RE: Application PZ23-000004 (DEV)
Oak Creek Heritage Lodge, Comprehensive Review,
Planning, Engineering, and Sustainability Comments

Response to Planning Comments dated May 24, 2023:

c) *LDC Section 5.7.F(4) & (5): Building Materials and Building Color*

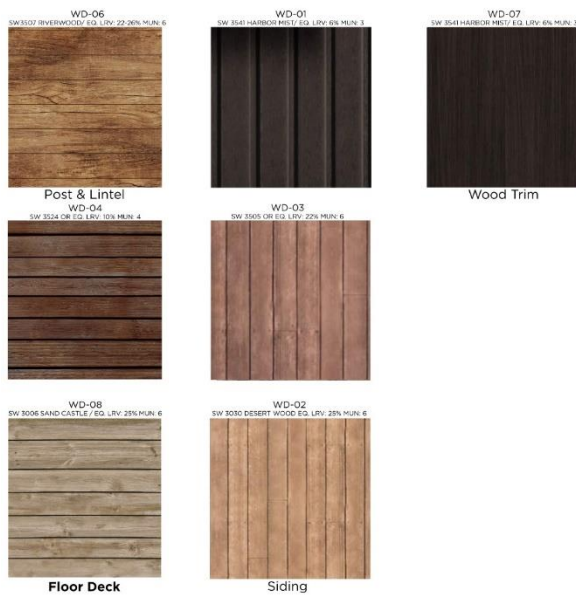
i) *Many of the colors provided exceed 21% LRV, which is what the plans use for alternate standard calculations. While trim colors may be permitted to be higher, the trim colors vs. siding colors are not differentiated on the materials board.*

WATG: Per the materials board and palette sheet, where vertical and horizontal siding is used, the corner, base, top, doors, and window trims will closely match the adjacent siding in hue/color/stain color. Where trim is used at facias, wall bands, terrace edges, posts etc., the intent is to use the darker trim color # WD-07. See elevation and Sheet A1-05.

WATG Exhibit for Planning Comment Item 10 “LDC Section 2.24.E: Heights Item #10 A(i)”:

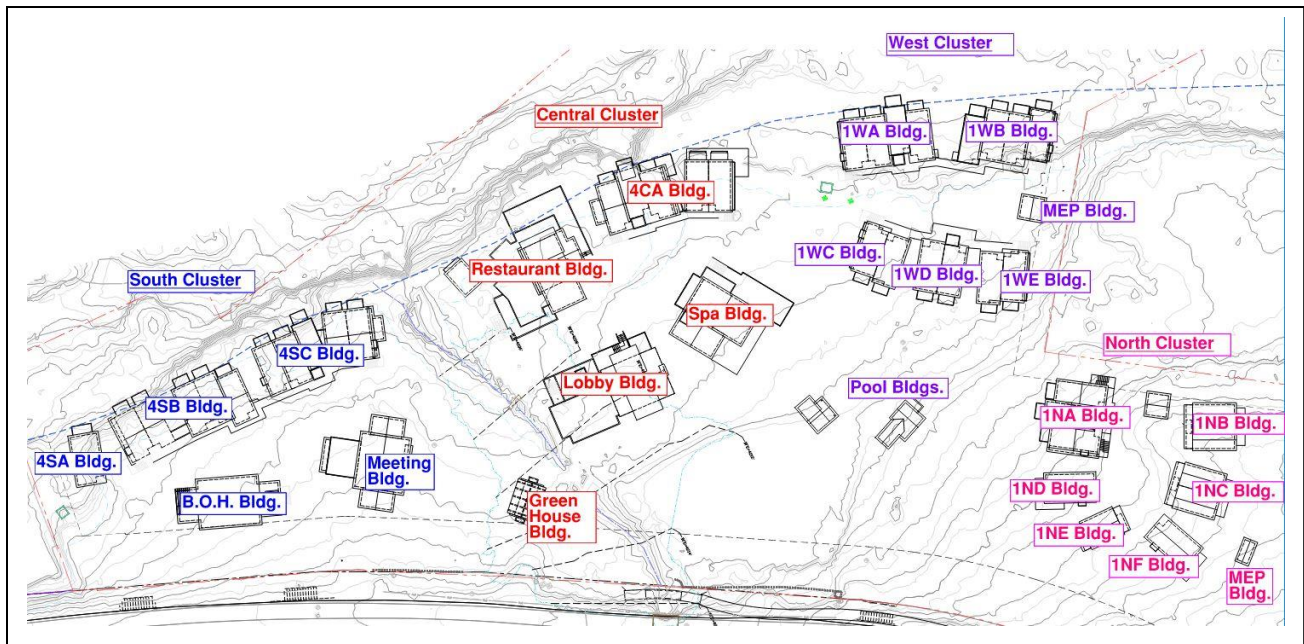
- i) *To assist in the review of the heights of all buildings, it would be helpful to have a height summary sheet, showing the maximum height above natural grade and the height allowances being applied to each building in a separate document.*

OCHL Height Narrative. Please see the roof plans for the corresponding buildings for reference of all heights, RFE’s, natural grade, etc. Each Roof Plan indicates which height exceptions are used relative to the specific site conditions.

E. BUILDING HEIGHT - PER 2.24.E.(1)d.2 Parallel Plane Measurement Utilized		
BUILDING HEIGHT LEGEND: PER 2.24 E.(1)d.2.g	T.O.R. = TOP OF ROOF	T.O.W. = TOP OF WALL
	T.O.P. = TOP OF PARAPET	
ALLOWABLE HEIGHT = +22’ ABOVE NATURAL GRADE OR RFE (2.24 E(1)c); APPLIES TO HEIGHT BEING MEASURED FROM THE REGULATORY FLOOD ELEVATION – RFE OR NAT. GRADE)		
(H1) HEIGHT INCREASE: 2.24 E.(3)Table 2.7: Chimneys +10’; Elevators +8’; Mech +8’; Gable/Pitched Roof at 3.5:12min. = +5’		
(H2) HEIGHT INCREASE: 2.24 E.(4)a.1.Table 2.8 MORE THAN 12 BLDGS.(for 1:3 ratio) 10% OF BLDG. FOOT PRINT = +5’		
(H3) HEIGHT INCREASE: 2.24 E.(4)b.1.2.Table 2.9 FOR REDUCED LRV = +2.5’ (LRV 21 Only)		
(H4) HEIGHT INCREASE: 2.24 E.(4)b.1.2.Table 2.9 FOR WALL PLANE RELIEF AND REDUCED LRV = +4.0’ (LRV 21+Wall Plane Max. of 500 sf)		
Note: For Exception H2. Total building area = 45,655 sf x 10% = 4,565 sf to utilize for additional Height. The Roof Plans herein total 3,340 sf of roof area against this exception. Under the 4,565 allowable. See Roof Plans for Buildings: 4SC; 1WA; 1WB; BOH Building; Lobby Building; Restaurant Building.
